“SAFETY RECALL NOTICE”
NATIONAL HIGHWAY TRAFFIC SAFETY ADMINISTRATION
RECALL NO: 15E013

RV QUAD STEP 24" x 8 x 8, RIVET REPLACEMENT	SRP 1502-0001 REV.B032715
---	-------------------------------------

RV QUAD STEP 24” x 8 x 8 - Hinge Point Rivet Replacement #55 @ 2nd & 3rd Step & Top Tread Mount Rivet #08 @ Inboard Mounting Position, LH & RH

HINGE POINT RIVET MARKED #96 @ 2nd & 3rd STEP

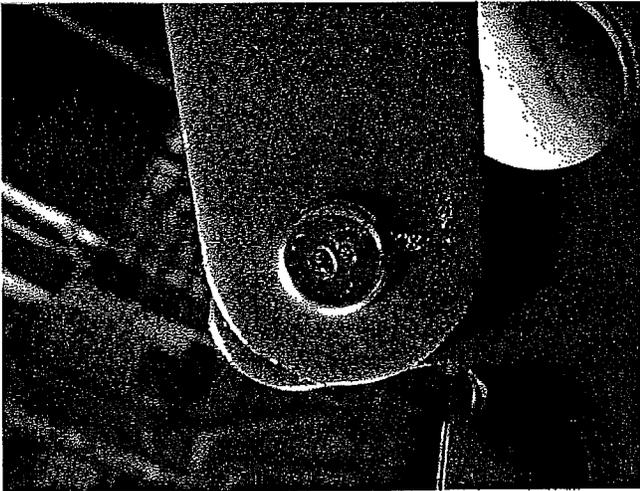
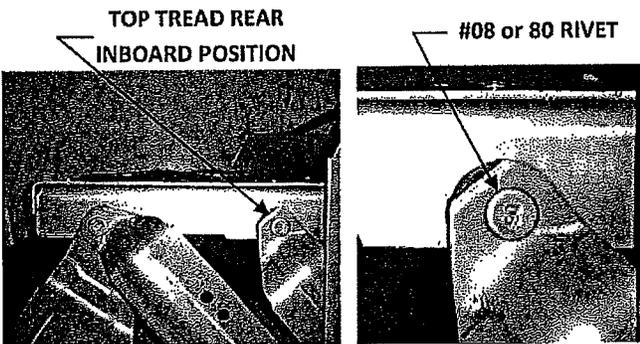
5.1.1 This configuration has a hinge point rivet marked with the #96 at the 2nd & 3rd Step (2nd & 3rd step, defined as the 2nd step from the ground level and the 3rd step from the ground level).

5.1.2 And a Top Tread mount point rivet marked with the # 08 or 80 at the rear inboard mounting position, both left and right sides.

NOTE: CONFIGURATION "A" - MUST BE REPAIRED IN ACCORDANCE WITH SRP-APPENDIX "A".

HINGE POINT RIVET MARKED #55 @ 2nd & 3rd STEP

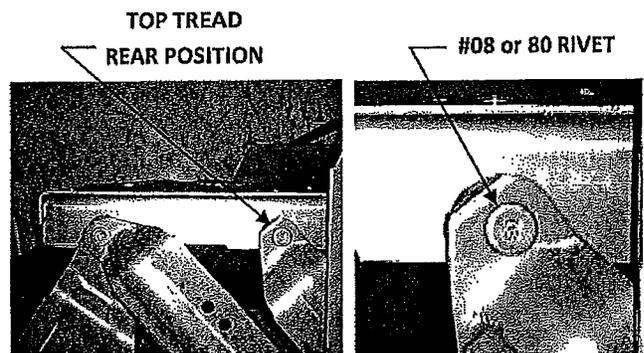
5.2.1 This configuration has a hinge point rivet marked with the #55 at the 2nd & 3rd Step (2nd & 3rd step, defined as the 2nd step from the ground level and the 3rd step from the ground level).

5.2.2 And a Top Tread mount point rivet marked with the # 08 or 80 at the rear inboard mounting position, both left and right sides.

NOTE: CONFIGURATION "B" - MUST BE REPAIRED IN ACCORDANCE WITH SRP-APPENDIX "B".

DRILL RIVET

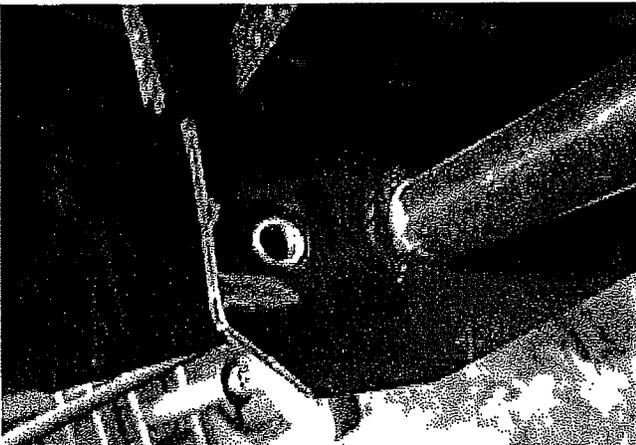
4.1 Drill The Rivet - Using a 3/8" drill bit, drill out the hinge rivet on the inner side of the step.

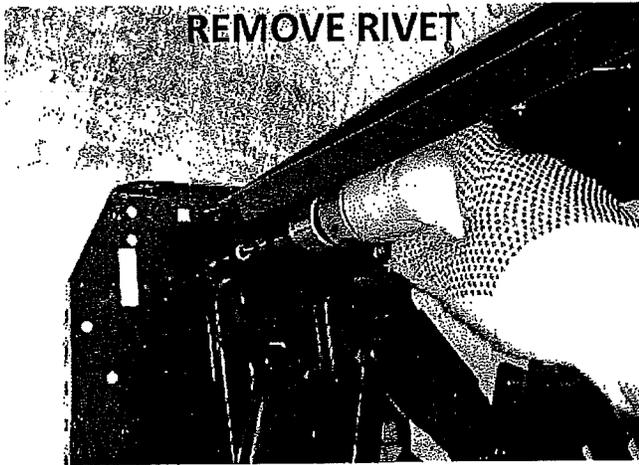
7.1 Drill The Rivet - Position yourself below the step, then using an air drill with a 3/8" drill bit, drill through the flange area of the Top Tread inboard rivet.

7.2 Remove Rivet - Remove the mounting rivet from the step bracket. If necessary use the 1/4" Drift Punch and Ballpeen Hammer to drive the Rivet from the mounting hole.

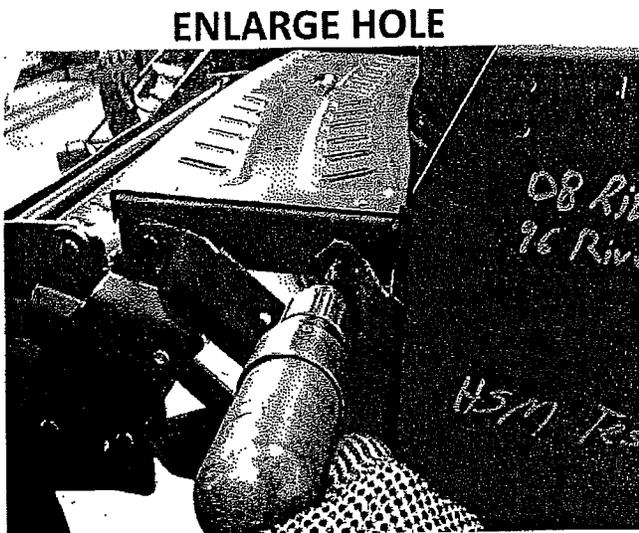
7.3 Enlarge hole of step plate assembly using a 3/8" drill bit. The linkage arm can be used as a guide by lifting up steps with one hand to line up holes of linkage arm and step plate assembly.

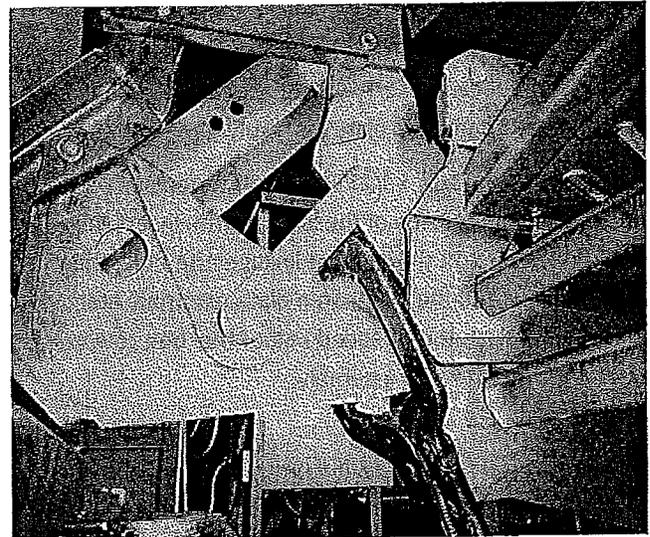
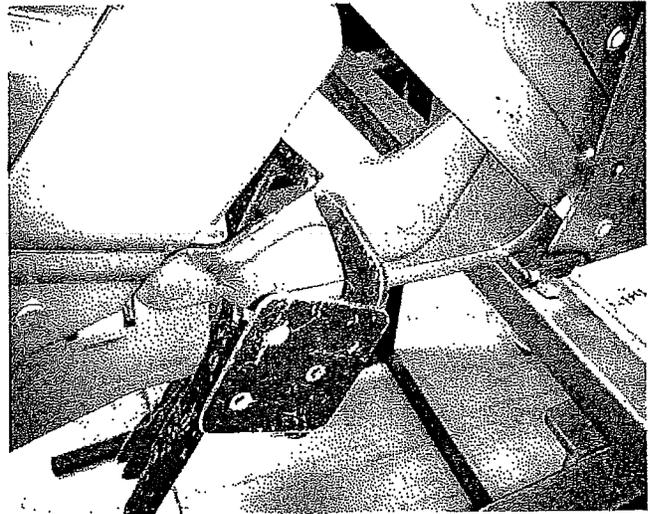
7.3.1 (Optional) Clamps can also be used as shown below to clamp step in position .

INSERT BOLT & WASHER

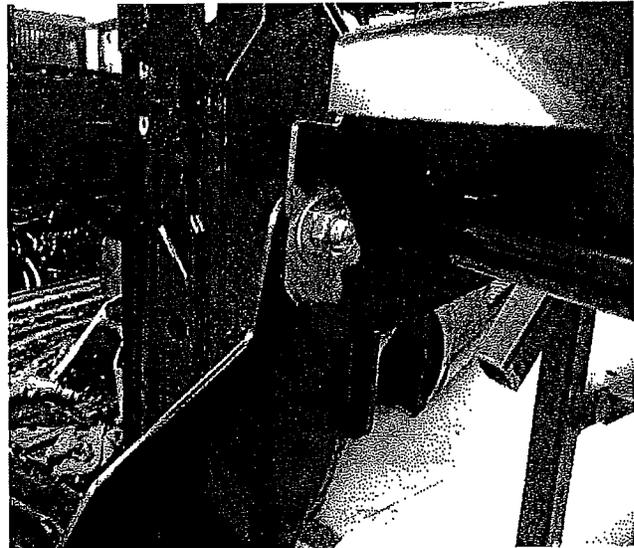
5.3 Insert Bolt (7/16" x 1" long bolt to replace 55 rivet) - From outside of the lower step hinge bracket, insert bolt through the hinge bracket hole, the Nylon Washer and the upper step hinge bracket hole. This should place the threaded end of the bolt toward the interior of the step assembly.

Note: Make sure the Nylon washer is located between the inner and outer brackets.

5.4 Install Flat Washer and Stover Nut onto end of bolt. Install to 12-16 ft. lbs. of torque for proper step operation.

DEPLOY STEP

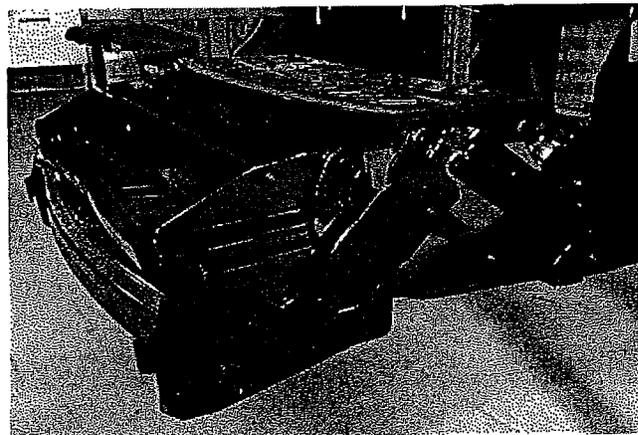
6.1 Deploy the RV Step - Deploy the RV Step from the stowed position, extending it outward to a resting position. This will position the Top Tread rivet in the best position for removal.

INSERT WASHER / BOLT

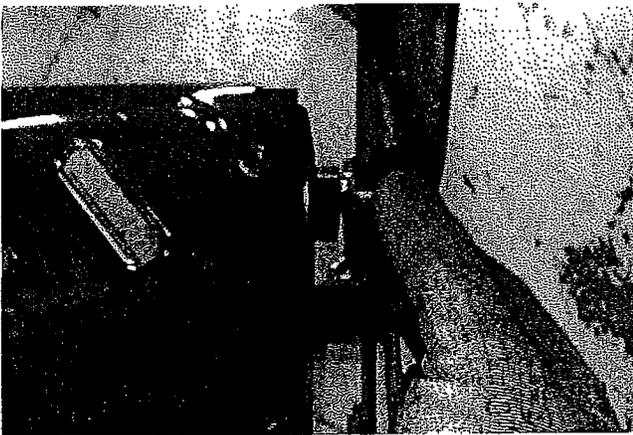
8.1 Align The Step - Align the step mounting hole at the RH side of the step. If necessary insert the 1/4" Drift Punch through the linkage hole as an alignment guide.

8.2 Insert Spacer - Insert Nylon Spacer between linkage arm and the upper step plate assembly.

8.3 Insert Bolt (3/8" x 1.25" long bolt to replace 08 rivet) - From outside of the linkage arm, insert the 3/8" Hex Head Bolt through the linkage arm hole, the Nylon Spacer and the upper step plate assembly hole. This should place the threaded end of the bolt toward the interior of the step assembly.

8.4 Install Flat Washer and Lock Nut - Install the 3/8" Flat Washer and 3/8" Stover Nut onto the end of the 3/8" Hex Head Bolt. Tighten the Stover Nut to 12-16 ft. lbs. of torque for proper step operation.
